February 7, 2001

Georgia Department of Natural Resources
Radioactive Materials Program
Attn: Eric Jameson
4244 International Parkway, Suite 114
Atlanta, GA 30354

This letter is in response to Scan Technologies' application to amend the SS&D registration for the COALSCAN 9200/9500 device. The answers to your questions are as follows.

Figure 1. Measurement Locations – Front of COALSCAN 9200/9500 Mk3. Electronics Access Doors.

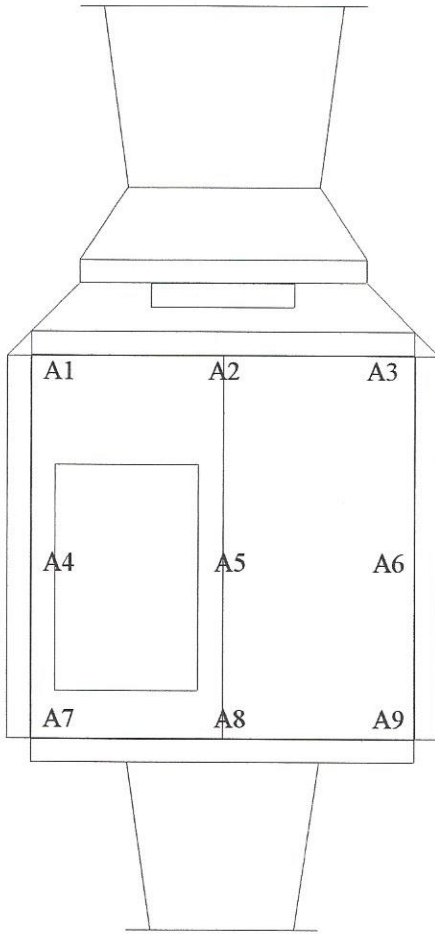
- a) Please provide diagrams showing the locations for points A1-A9 and B1-B9.

The measurement locations for points A1-A9 and B1-B9 are depicted in Figure 1 and Figure 2 respectively in the application. I have included a copy of Figures 1 and 2 with this letter.
